UNITED STATES PATENT AND TRADEMARK OFFICE

APPLICATION NO.	FILING DATE	FIRST NAMED INVENTOR	ATTORNEY DOCKET NO.	CONFIRMATION NO.
10/544,188	09/30/2005	Marnix Van Der Mee	124873	8302
25944	7590	03/15/2006		
OLIFF & BERRIDGE, PLC P.O. BOX 19928 ALEXANDRIA, VA 22320			EXAMINER TA, THO DAC	
			ART UNIT 2833	PAPER NUMBER

DETAILED ACTION

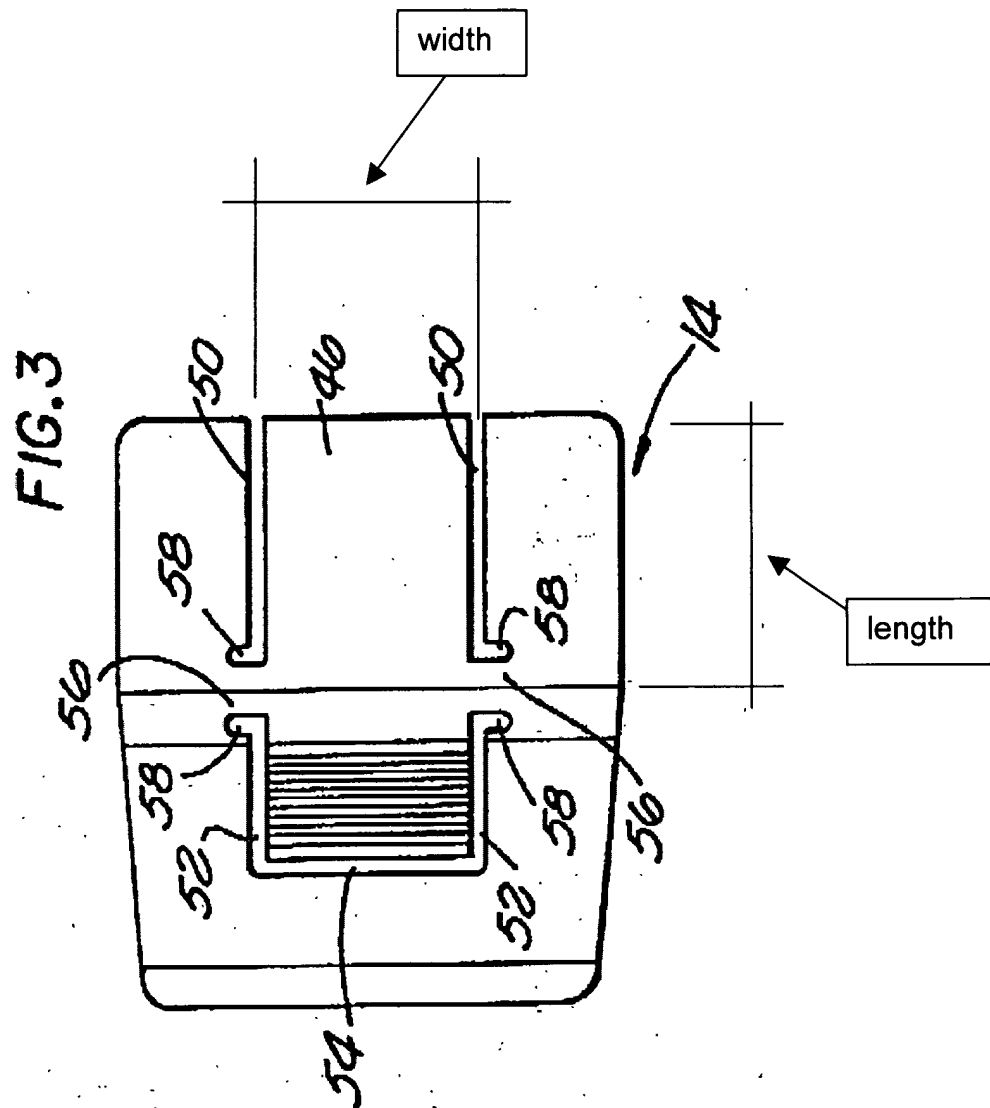
In regard to claim 17, Anhalt et al. discloses an electrical connector having a housing comprising: a first housing element 14 provided with at least a first connection

portion that is female; and a second housing element 12 provided with at least one second connection portion that is male, respectively, suitable for co-operating with the first connection portion; the first connection portion including at least one elastically deformable tab 46 made integrally with the corresponding connection portion in the thickness of a cylindrical of the connection portion, which wall defines a single cavity that presents, in cross-section, at least one side in the form of a straight line segment, the tab 46 extending, in cross-section, along the side, wherein the tab 46 presents, in cross-section, a width that is greater than half the length of the side (see attached drawing).

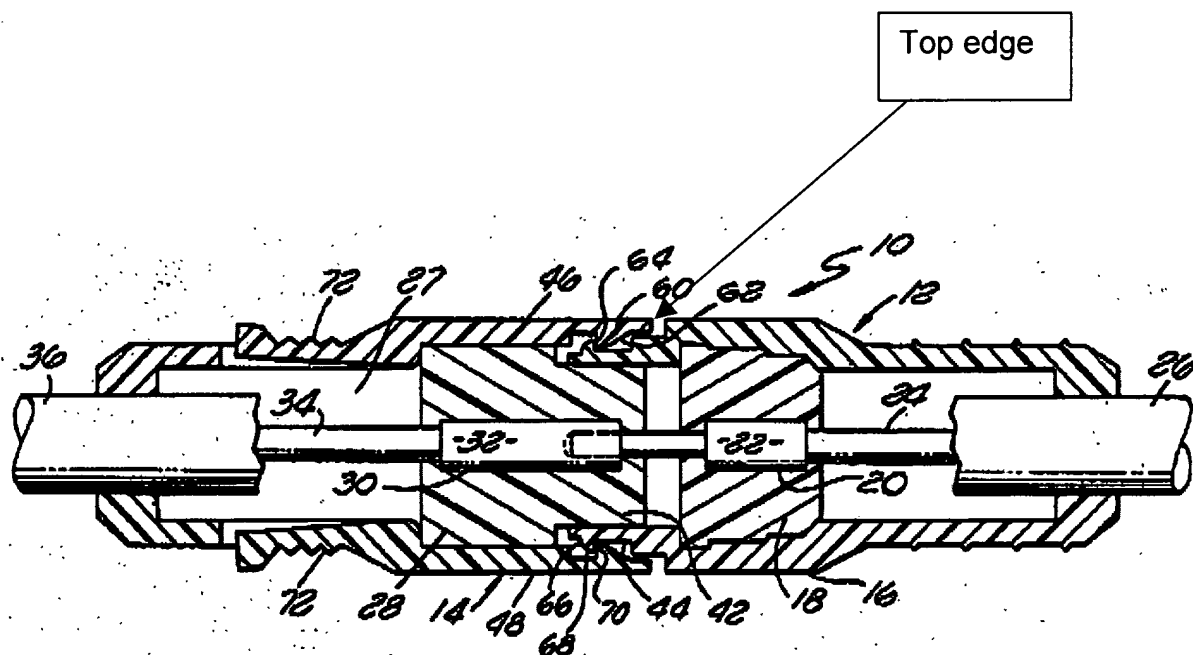
In regard to claim 23, Anhalt et al. discloses that the at least one tab 46 has a top edge (see attached drawing), wherein the at least one portion 60 in relief is adjacent to the top edge or is situated in the proximity thereof.

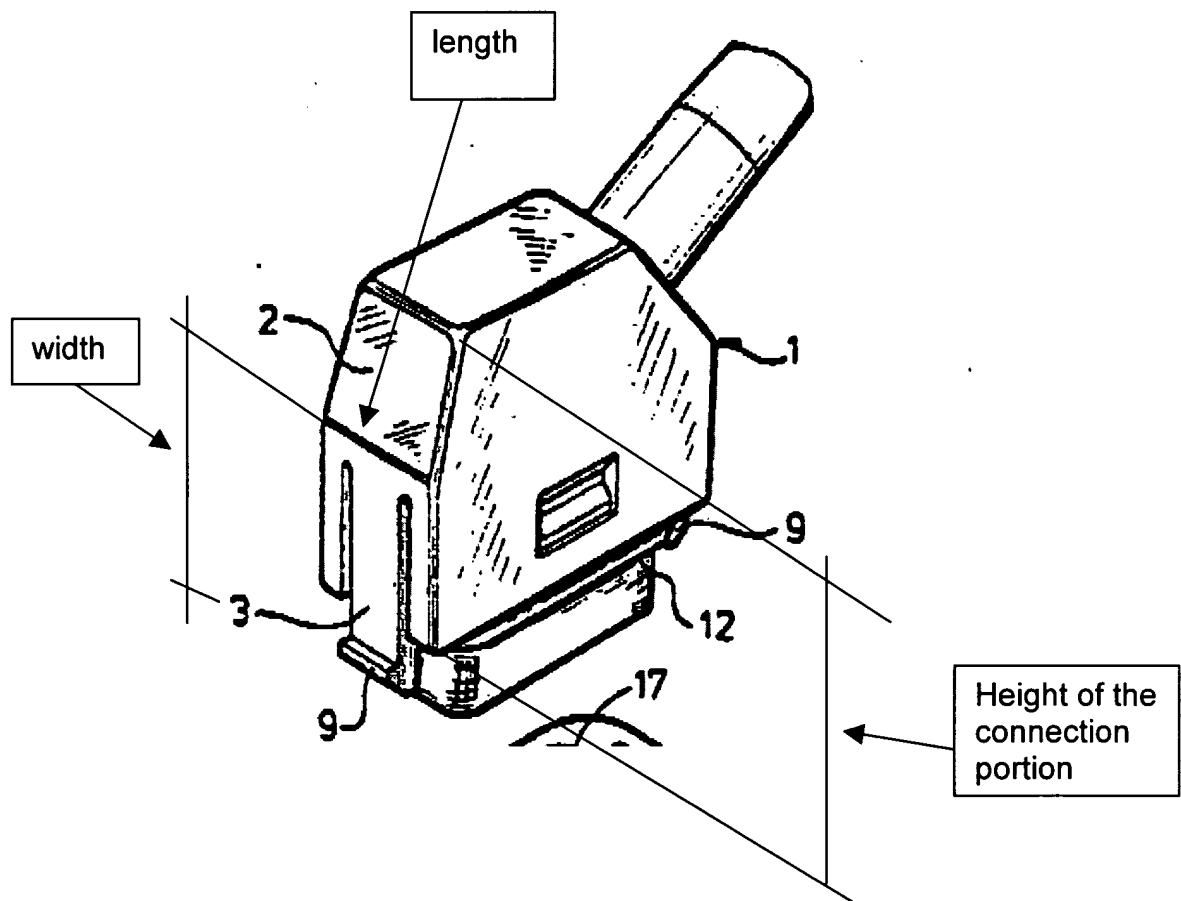
In regard to claim 17, Mouissie discloses an electrical connector having a housing comprising: a first housing element 1 provided with at least a first connection portion that is male; and a second housing element 4 provided with at least one second connection portion that is female, respectively, suitable for co-operating with the first connection portion; the first connection portion including at least one elastically deformable tab 3 made integrally with the corresponding connection portion in the thickness of a cylindrical of the connection portion, which wall defines a single cavity that presents, in cross-section, at least one side in the form of a straight line segment, the tab 3 extending, in cross-section, along the side, wherein the tab 3 presents, in

cross-section, a width that is greater than half the length of the side (see attached drawing).
